UNITED STATES
NUCLEAR REGULATORY COMMISSION

WHITE SANDS MISSILE RANGE (WSMR) INVESTIGATION OF
TWO LEAKING COBALT-60 SOURCES. LICENSE
NUMBER 30-02405-10

The following is a summary of the investigation of the leaking sources. The apparent cause of the failures was a design problem in the carrier-source configuration.

4100 CURIE COBALT CARRIER ASSEMBLY
MODEL NPI-16-4000

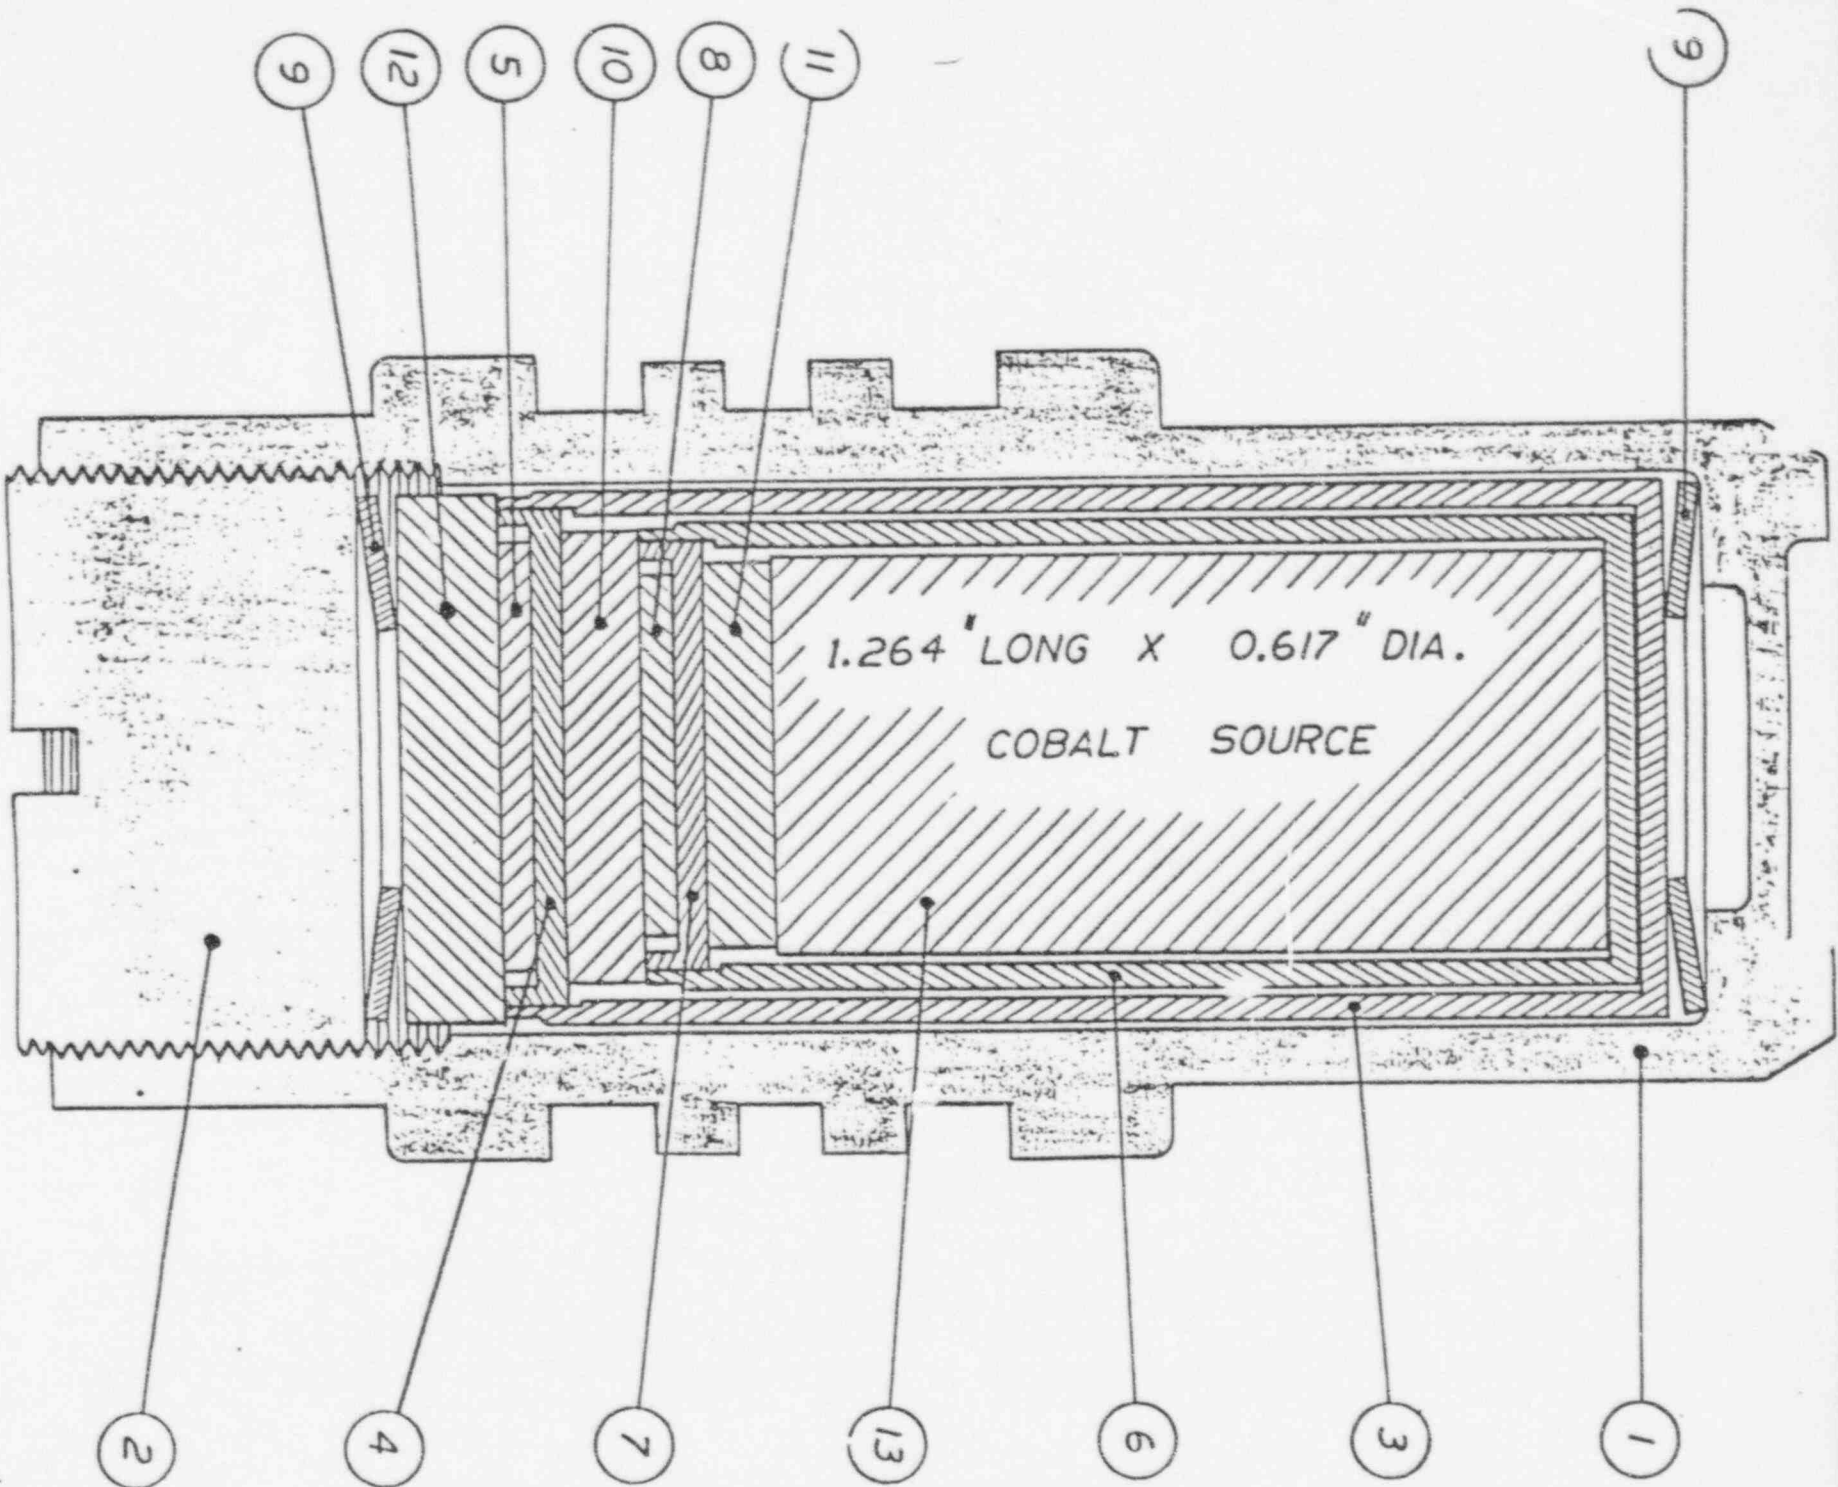
A possible issue is that neither NPI nor WSMR could clearly document why they started using belleville springs in the carrier. Also, in the early 80's, WSMR requested that NPI weld the threaded plug in place to further reduce the likelihood of leakage. Other facts of interest were presented by WSMR as follows: some corrosion problems have been identified in the exposure head of the device due to humidity in the compressed air system; it is not clear as to what the actual pressure applied to the carriers does to the location of the pressure valves; based on the last 2 years operational data, only one stuck source has occurred and it was moved using about 300 psi instead of the normal 10-20 psi; the radiography source movement system is designed to use 1500 psi nitrogen for stubborn stuck sources; heat treating of the carriers was done in the mid 80's, but the reason is not known and; WSMR staff are compiling historical use data to be used in its investigation of the event. WSMR appears to exercise flexibility in what the users of the irradiators can do without a conscious decision as to the cause and effect of the change on the entire system.

NPI performed swipe tests on the carriers. The test results identified levels of contamination above .005 microcurie. A helium bubble test conducted on both carriers had negative results; that is to say no bubbles were observed. The first capsule (SN 17591, from port number 5) was machined off at the carrier threaded end plug and the source was removed. The outer encapsulation of the source was deformed (the end cap was convex and showed signs of weld failure). An attempt was made to separate the outer and inner capsules, however, the end cap broke off (window end). The inner capsule weld failed at what appeared to be the end cap of the inner capsule. Examination of the belleville springs inside the capsules showed apparent deformation.

Based on our analysis of the above data and the design of the carrier, the source failed because of design of the carrier source/configuration. This design did not appear to use good engineering principles to eliminate stress concentrations where possible, but rather concentrated them. As a result, we asked WSMR personnel to include a redesign of the carrier and design validation program in its response to Region IV verbal request for an investigation plan. Such a program must consider all factors the sources are exposed to during use, transport, storage, etc. The design change should consider, but not be limited to, the following issues: 1) elimination of the belleville springs, 2) redesign of the carrier, 3) possible source capsule redesign for this application and (4) a heat treatment (anneal) of the source capsule. We strongly suggested that WSMR do prototype testing of a dummy source to demonstrate the effectiveness of any design change.

We also suggested that WSMR provide a realistic schedule for design change and validation. This schedule should address the issue of replacing the sources, because it is very likely the sources currently in the system will be damaged and leak. We recognize that it is difficult to determine when it will leak, however, the sources should be replaced before the normal 5-year period, and as soon as a design change validation is completed and when the vendor can provide new sources.
